HISTORIC PRESERVATION BOARD

HISTORIC PRESERVATION BOARD MEETING

PUBLIC HEARING
102 STATE STREET (Winter Street frontage)

WINTER STREET TOWNHOMES

PLANT LIST

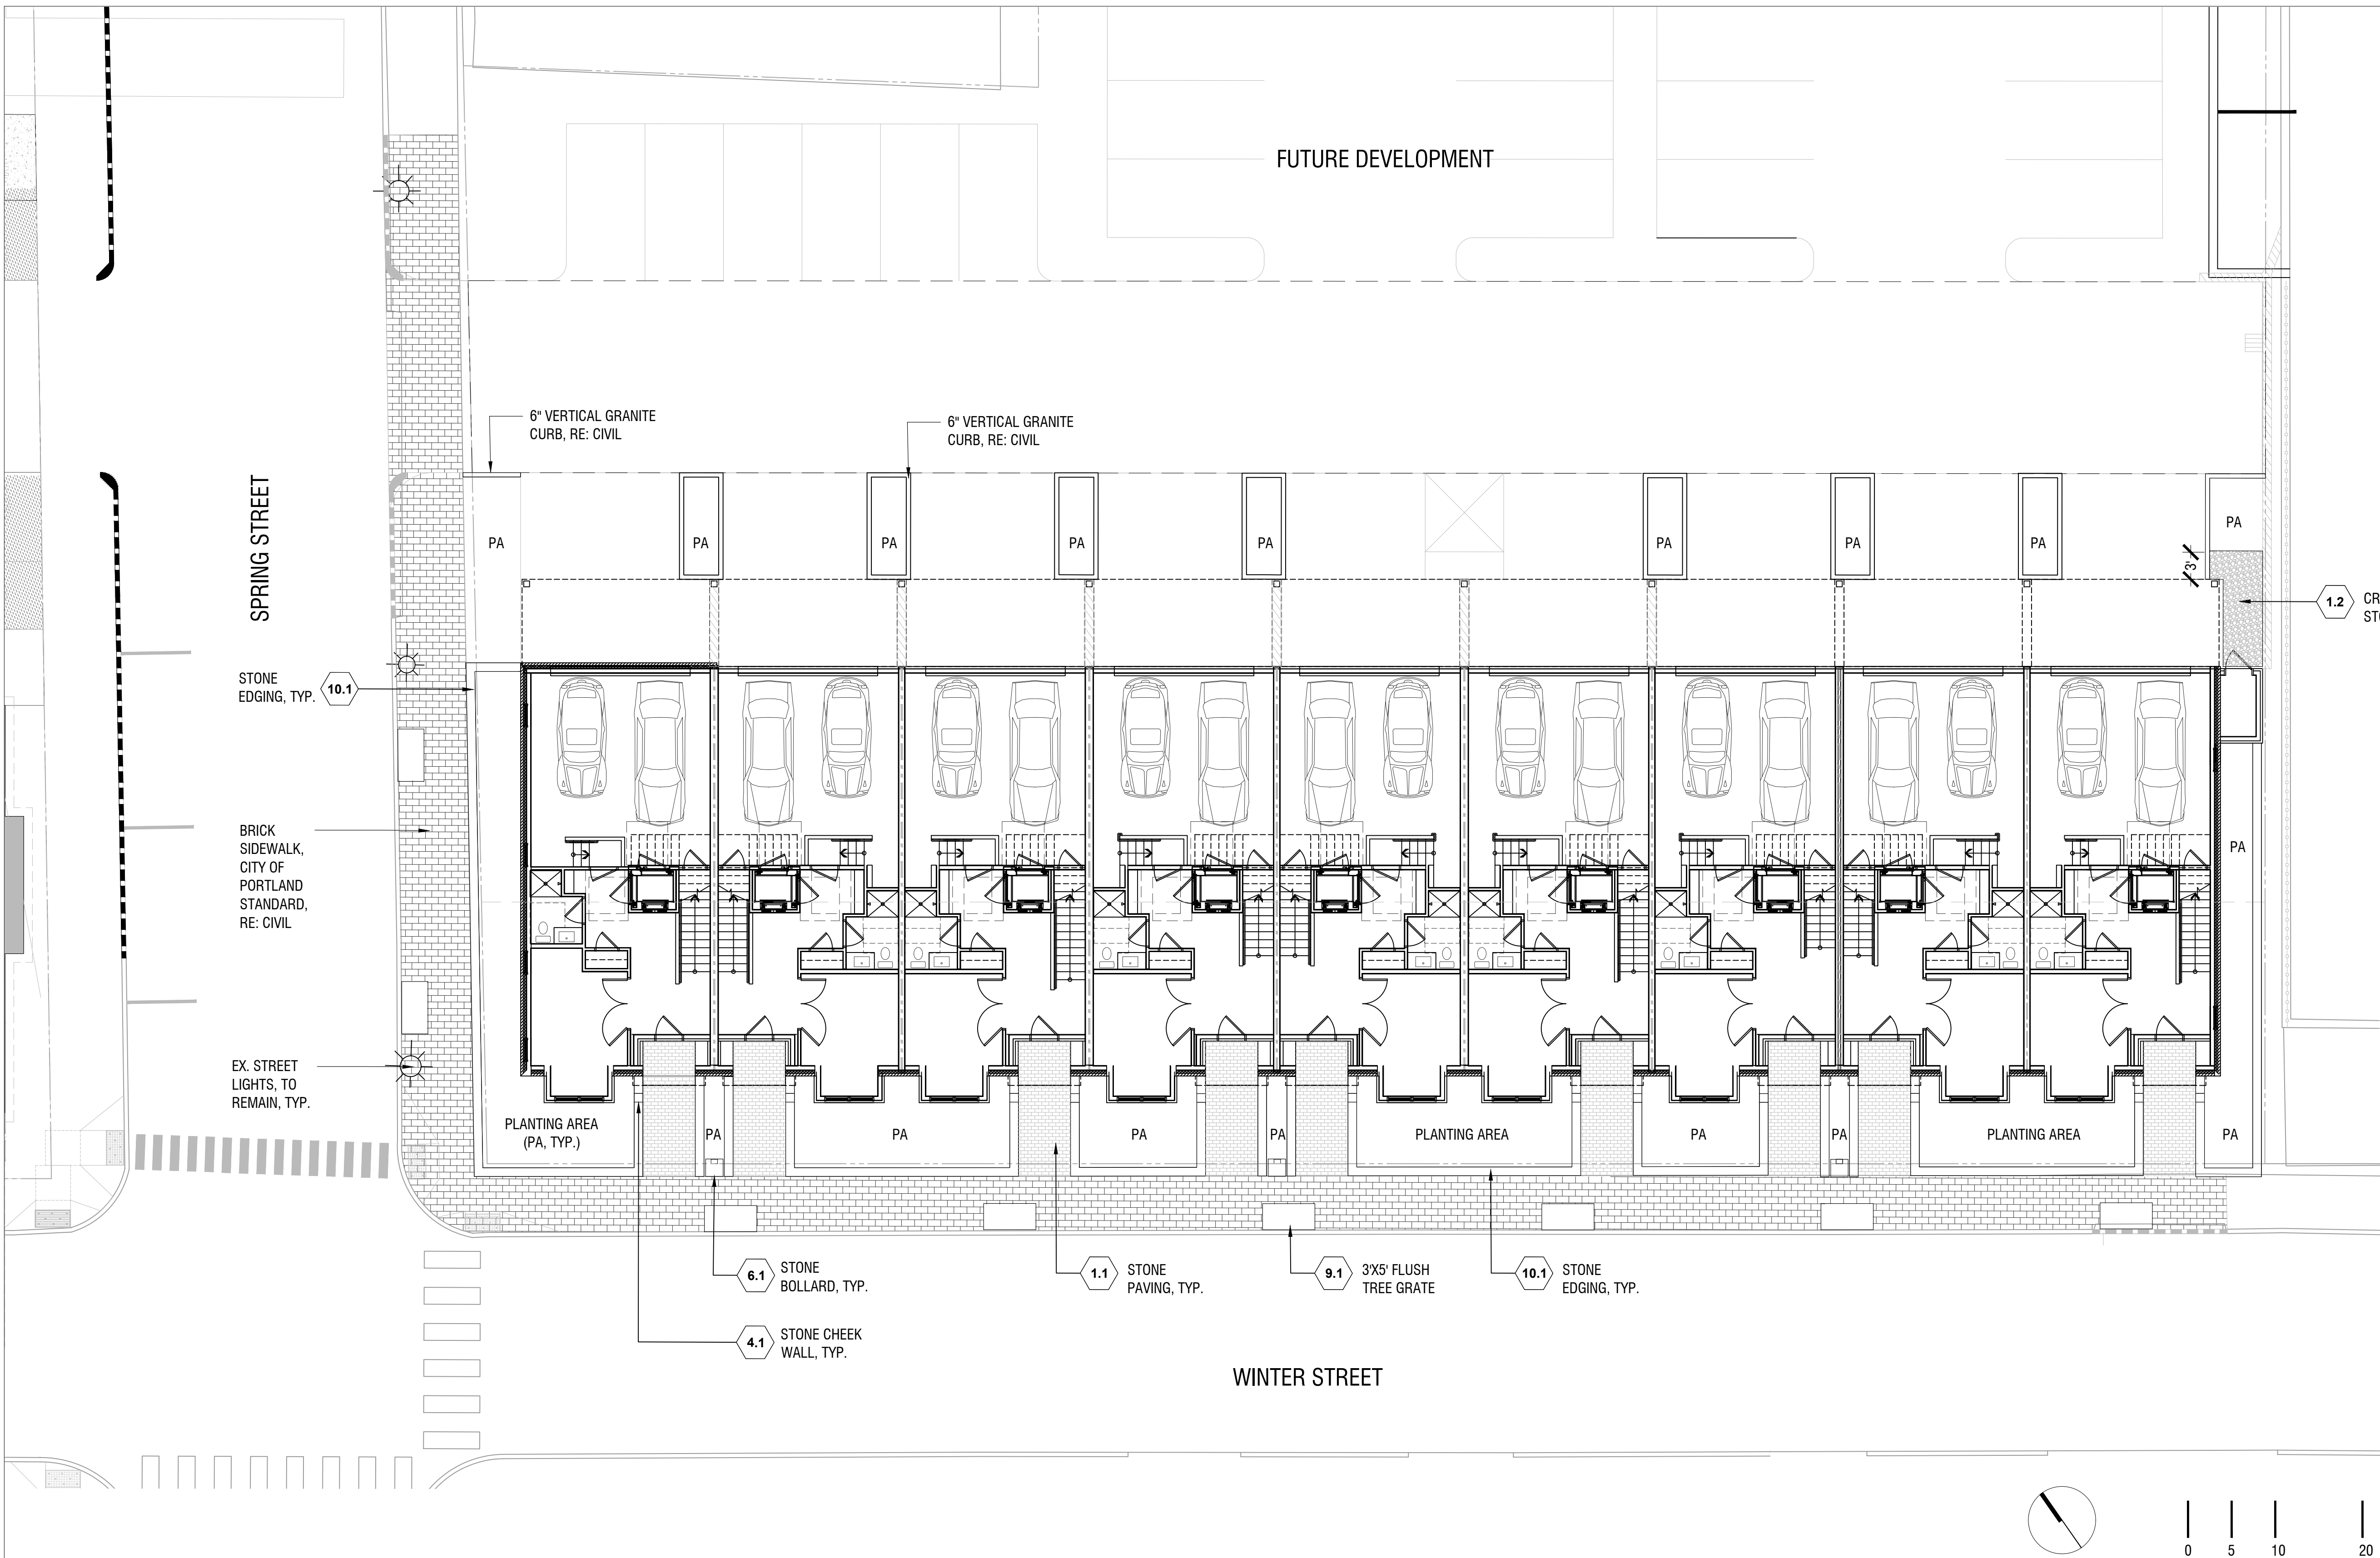
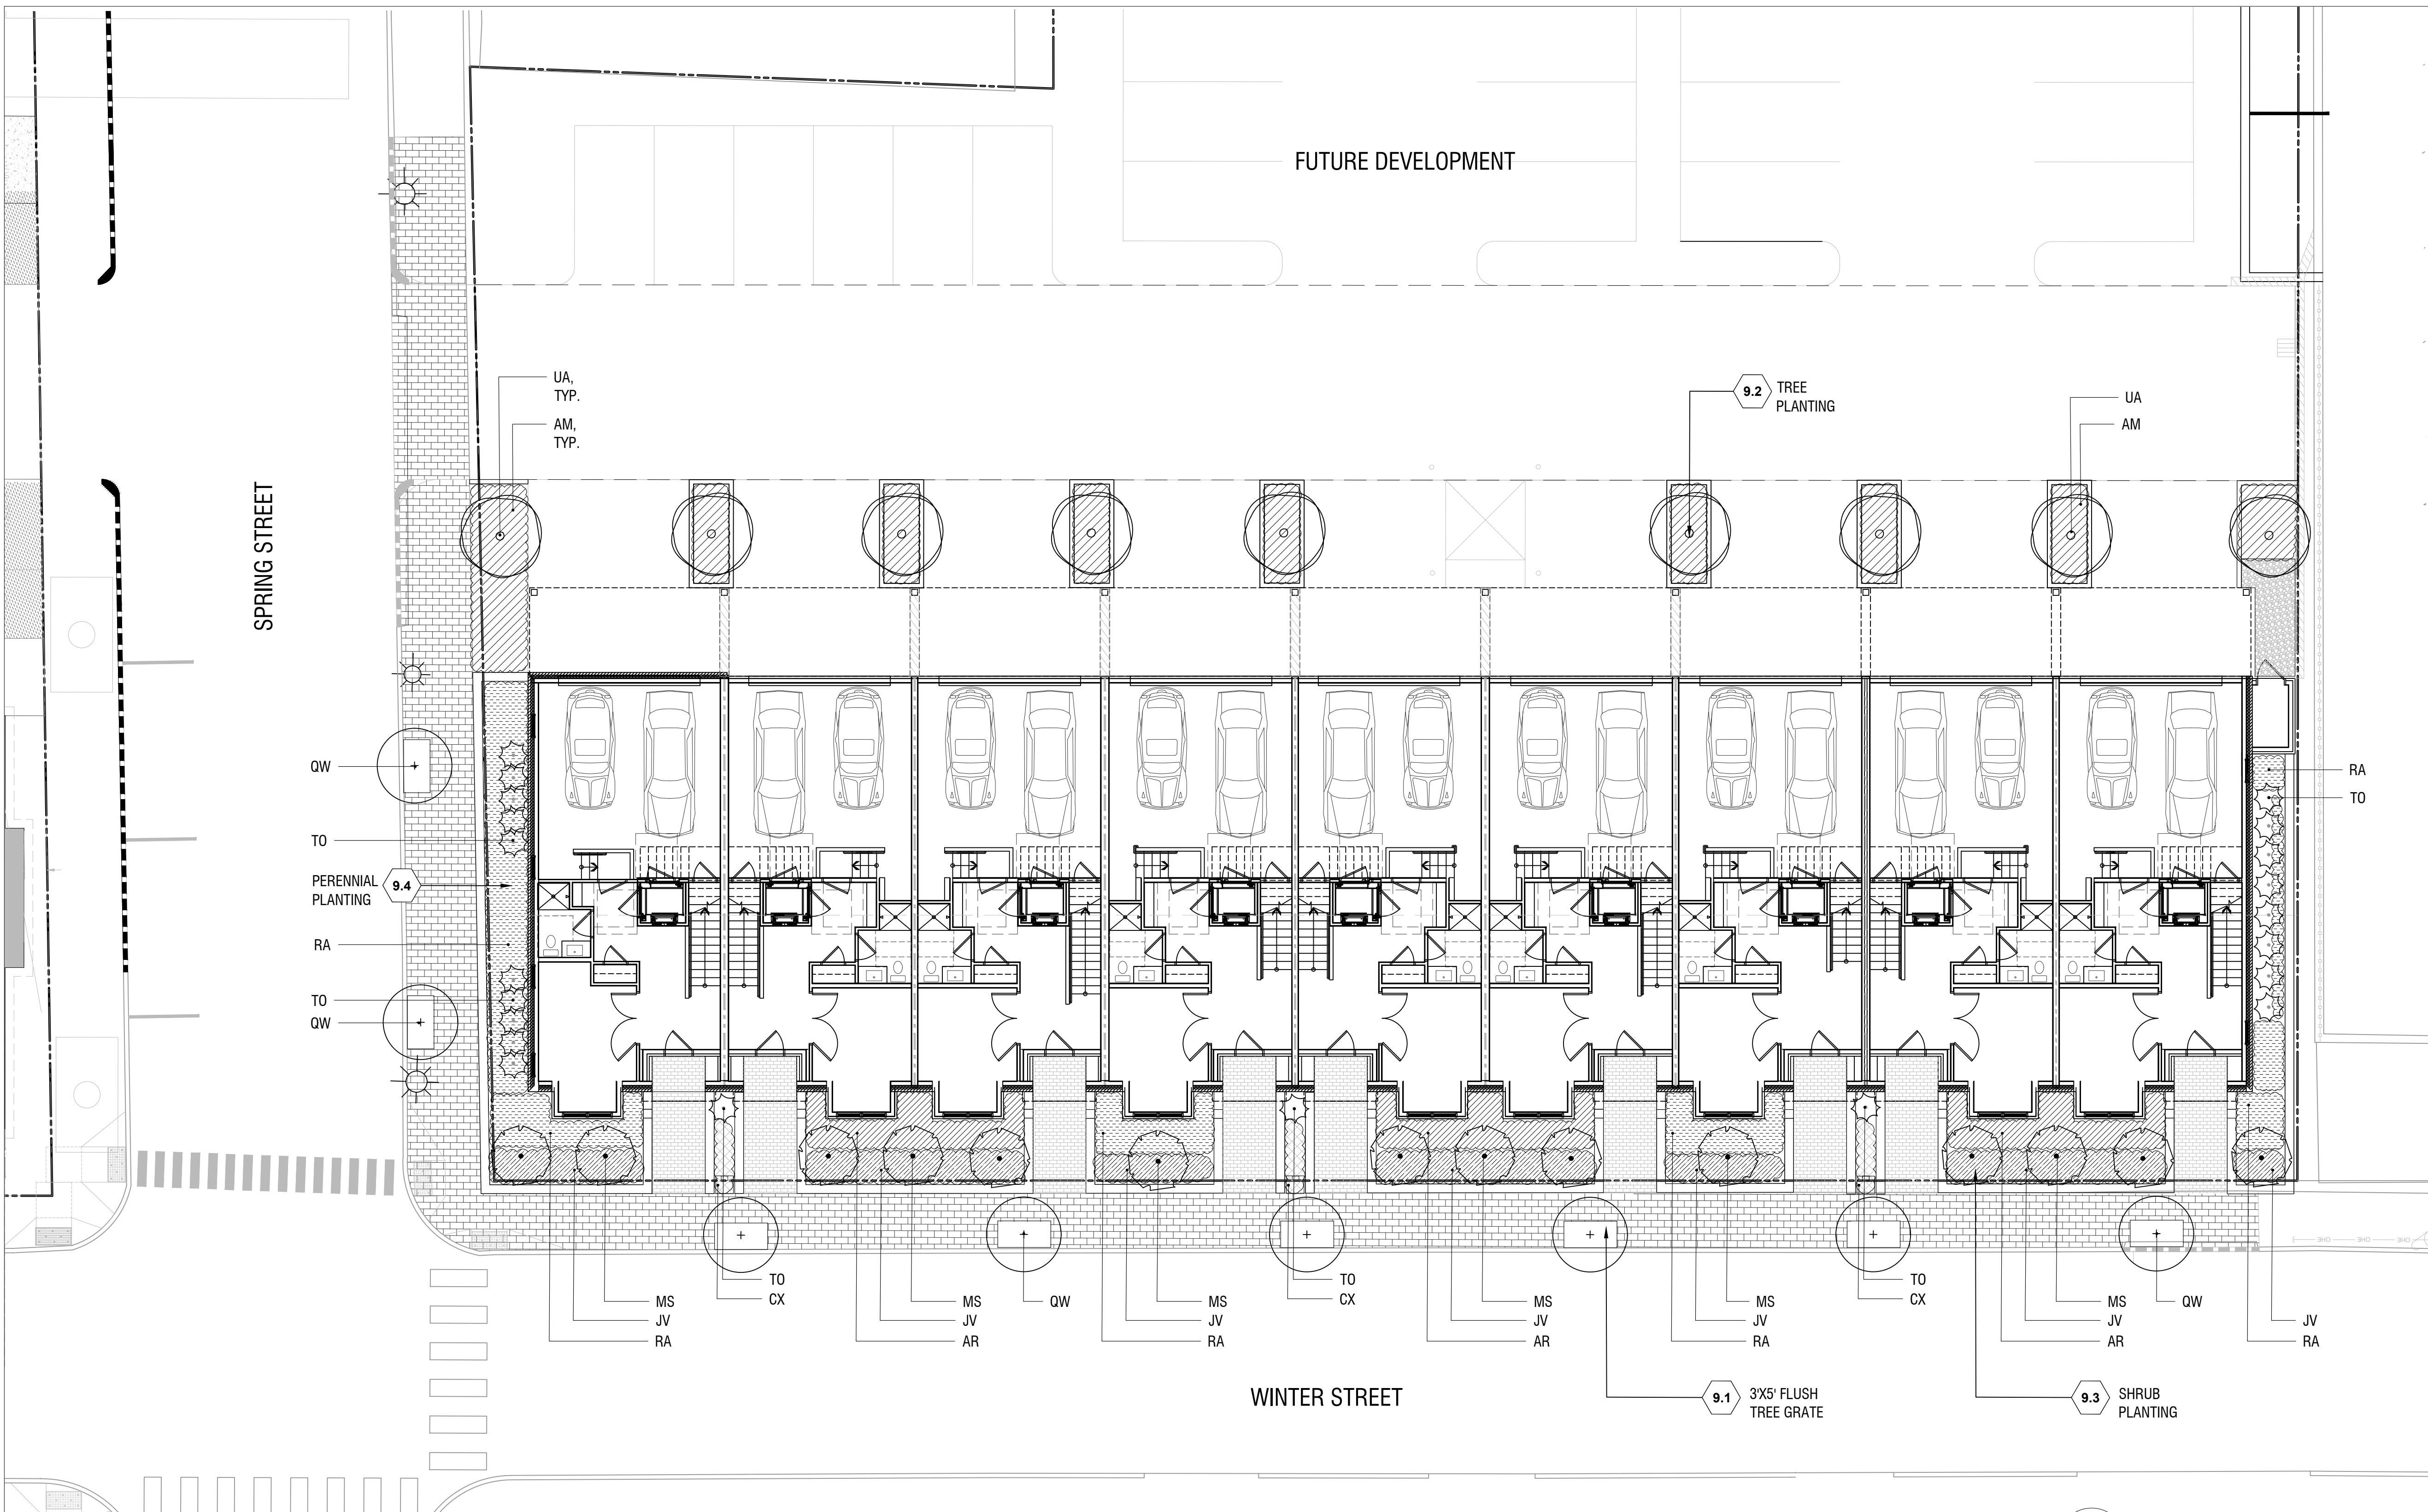
- Regarding the landscape plan, Board members favored woody plant material (instead of ornamental grasses) in the front beds, consistent with the landscape character of the neighborhood. Also, the arborvitae shown in the planting bed dividing the individual townhouses was found to be out of scale.
The planting scheme for the front yards has been revised to provide more contextual plantings. The size of the Arborvitaes has been reduced. Note that the updated landscape plans provided in ATTACHMENT 4 show the corrected scheme..

- 2.) We have revise the landscape design and reduced the size of the Arborvitae's between residential entrances.
- 3.) We have simplified the detailing of the bays by removing the additional beaded trim within the panel areas, this results in a more consistent, clean and contemporary detailing of the facade so the bays and entry canopies relate more effectively.
